# A12 Chelmsford to A120 widening scheme

TR010060

## 9.41 Applicant's Responses to ExQ2

**Applicant's Responses to ExQ2**

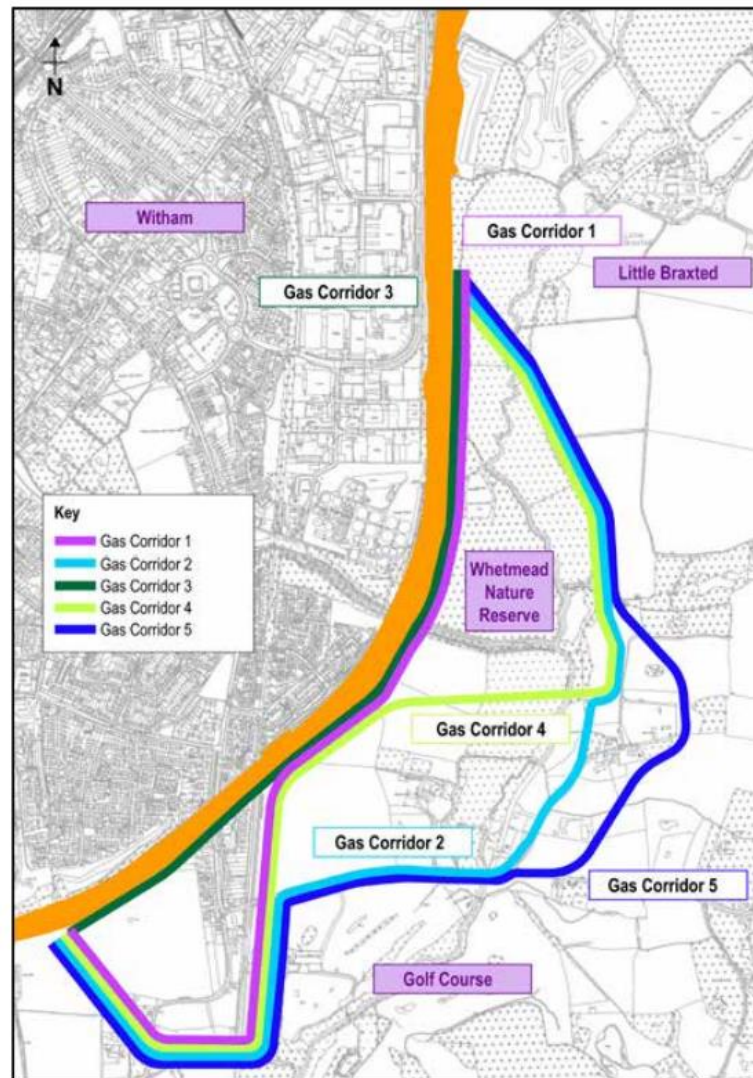
During the ASI the ExA observed the ecological value of the Blue Mills Nature Reserve and adjoining Ancient Woodland. Please summarise: • the alternative options considered which would avoid or mitigate the impacts of routing the pipeline diversion through the nature reserve; and • justify the reasons why each option has been discounted.

##### Alternative options considered

During the Supplementary Consultation in November 2021, as well as the plans showing the corridors, an illustrative sketch of the corridors was included on page 23 of the consultation brochure [APP-057] which is copied below for ease of reference.

### **Views of the bridge**

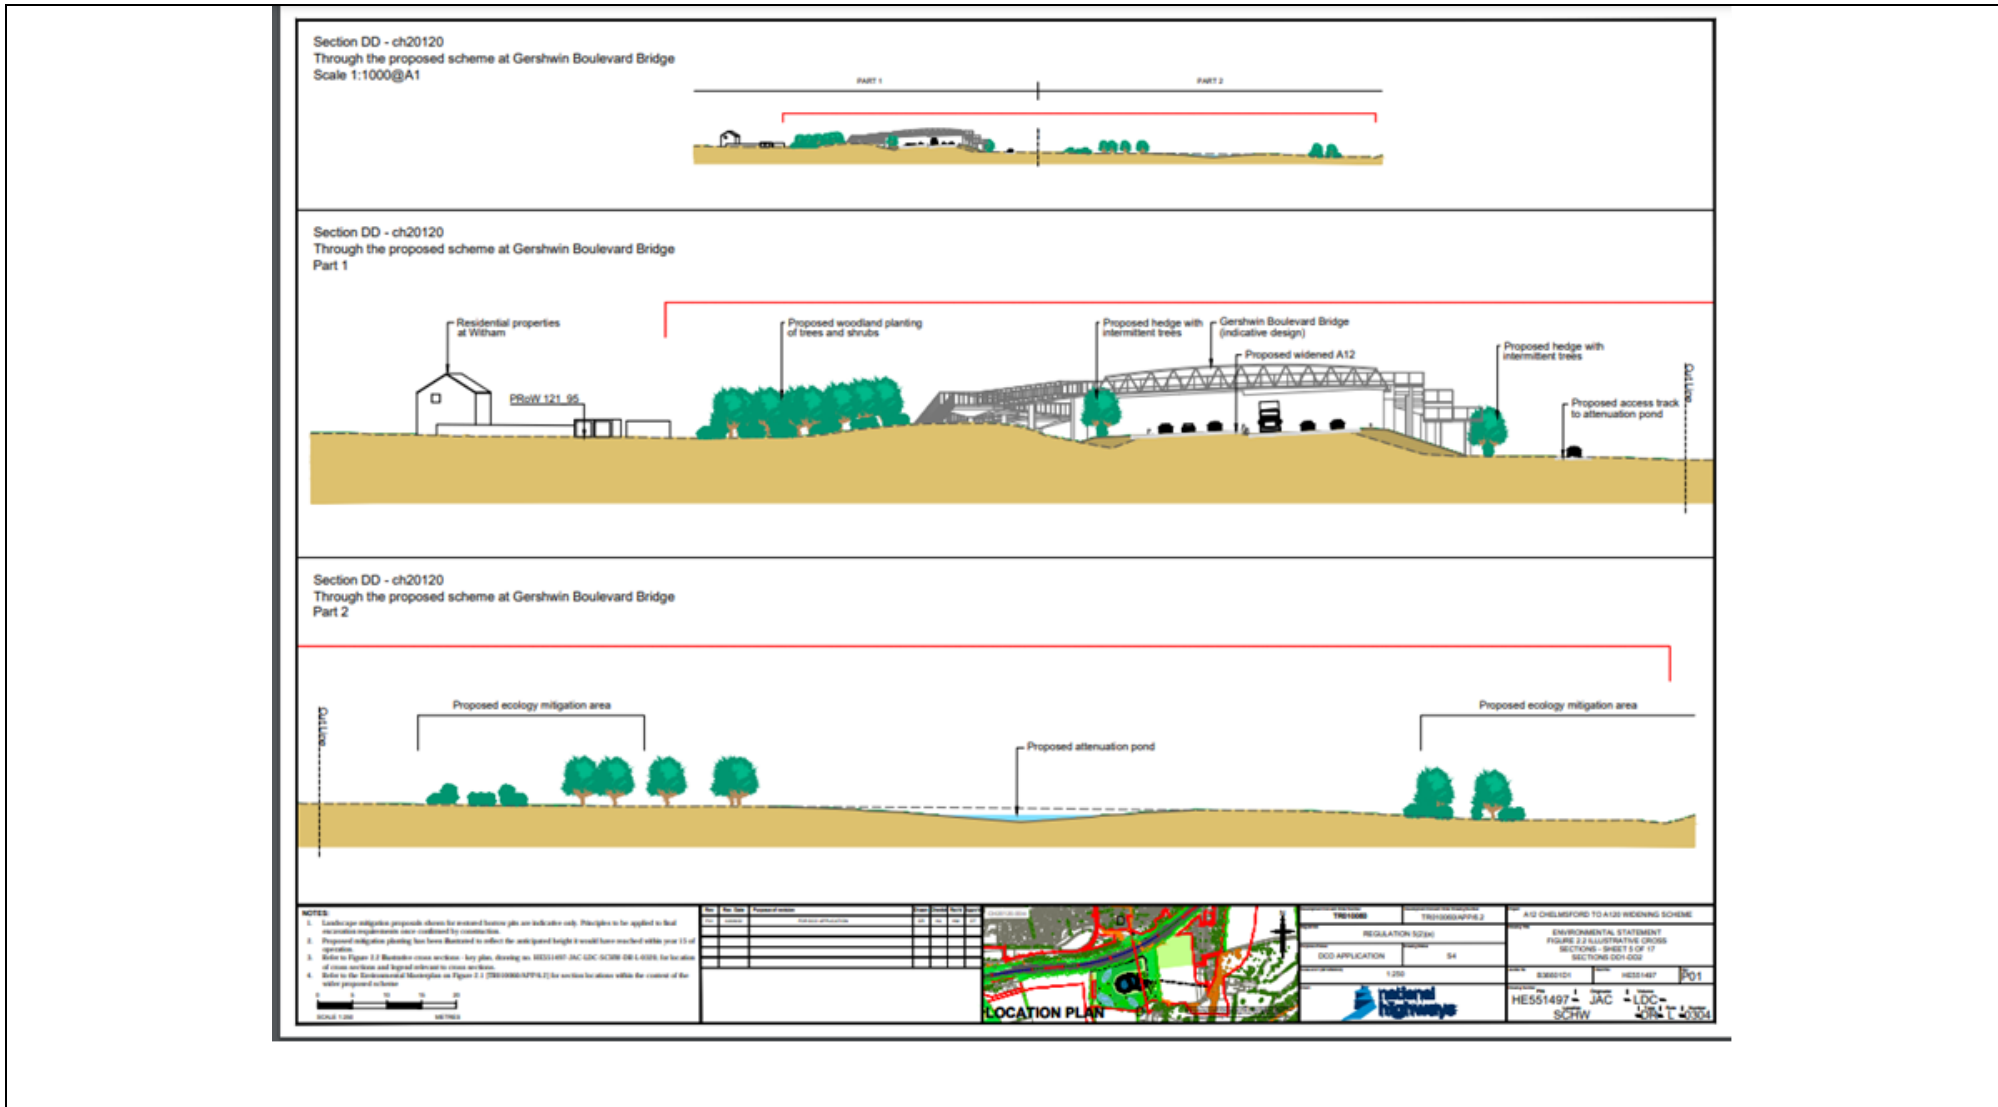
A specific note concerning the Gershwin Boulevard Bridge has been lodged at REP3-011. This includes a plan, photographs and consideration of an alternative siting. Mr Keith Lomax spoke at the hearing and has lodged a representation at REP3-046. Does the Applicant wish to provide any additional information in response to this?

The Applicant acknowledges that some residents will have views of structure however, from the nearest part of the structure:

- For Oliver's Drive residents there is approximately 50m to the nearest window
- For Maldon Road residents there is over 130m to the rears of the gardens and in excess of 150m to the houses.

The proposed Gershwin Boulevard Bridge is assessed as having a very large adverse visual effect on the representative viewpoints presented in REP3-011 during construction and in year 1. At year 15 when mitigation planting has established this would reduce to a moderate adverse visual effect.

**Updated Plate 7.7 River Blackwater floodplain at Ashman's Bridge – modelled change in flood levels as a result of the proposed haul road and piling rig (5% (1 in 20) AEP event)**

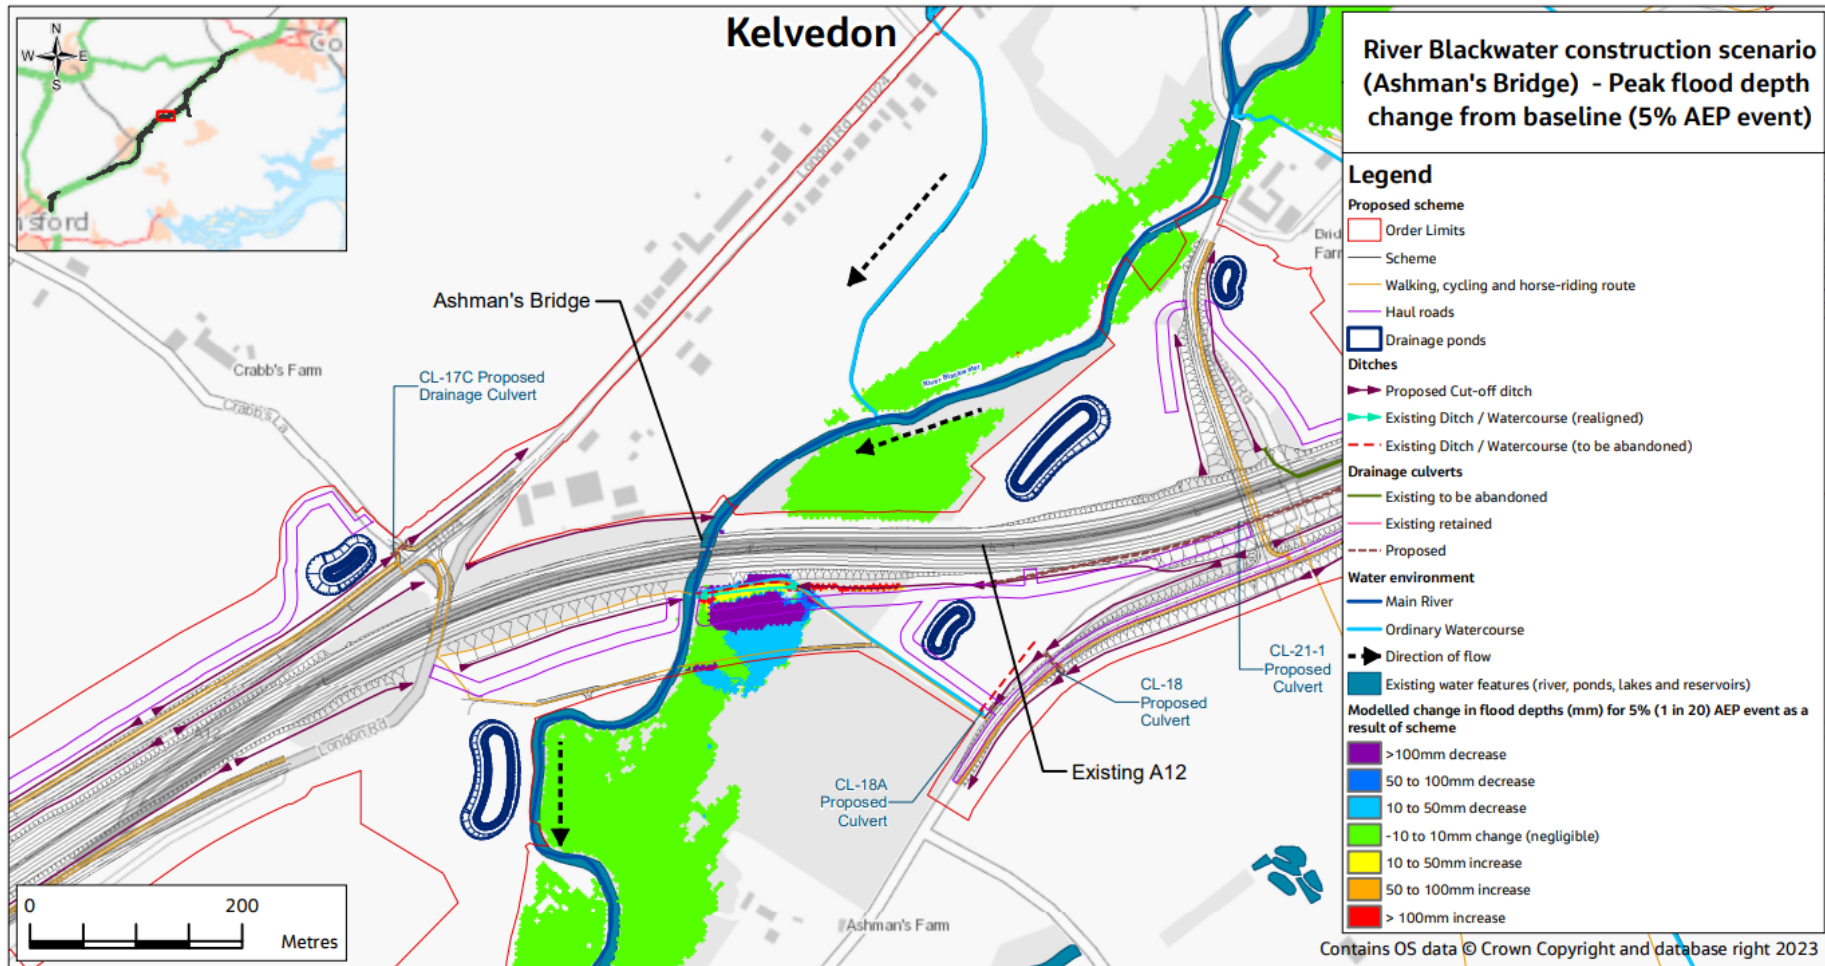
- Upstream of the A12 crossing on the River Blackwater, the Applicant has noted that the change in risk displayed in Plate 7.8 of the Flood Risk Assessment [APP-162] is a result of an error in the information displayed in that document. There is no adverse impact identified outside the Order Limits and no requirement to inform the landowner of a change in flood risk. A corrected version of this figure has been prepared and is provided in Appendix A to this submission and will be provided to the Environment Agency.
- The other area where similar agreement will be sought with the landowner relates to the River Blackwater floodplain east of Witham (as shown in Plate 7.4 of the Flood Risk Assessment [APP-162]). Materials to present to the landowner have been prepared and will be shared the landowner for their consideration in advance of Deadline 5.

- 1.1.1 Plates 7.7 and 7.8 in Appendix 14.5 Flood Risk Assessment (FRA) of the published Environmental Statement [APP-162] had previously included incorrect with-scheme modelling data (including both the permanent proposed scheme and the haul road to represent the worst-case scenario) for the 5% (1 in 20) Annual Exceedance Probability (AEP) and 1% (1 in 100) AEP events.

- 3.1.1 As shown in updated Plates 7.7 and 7.8 and as stated in the FRA, the proposed scheme (permanent works plus construction elements) results in negligible impact (less than 10mm change in flood levels) on flood risk. Therefore, it is considered that no temporary flood mitigation would be required in this location.
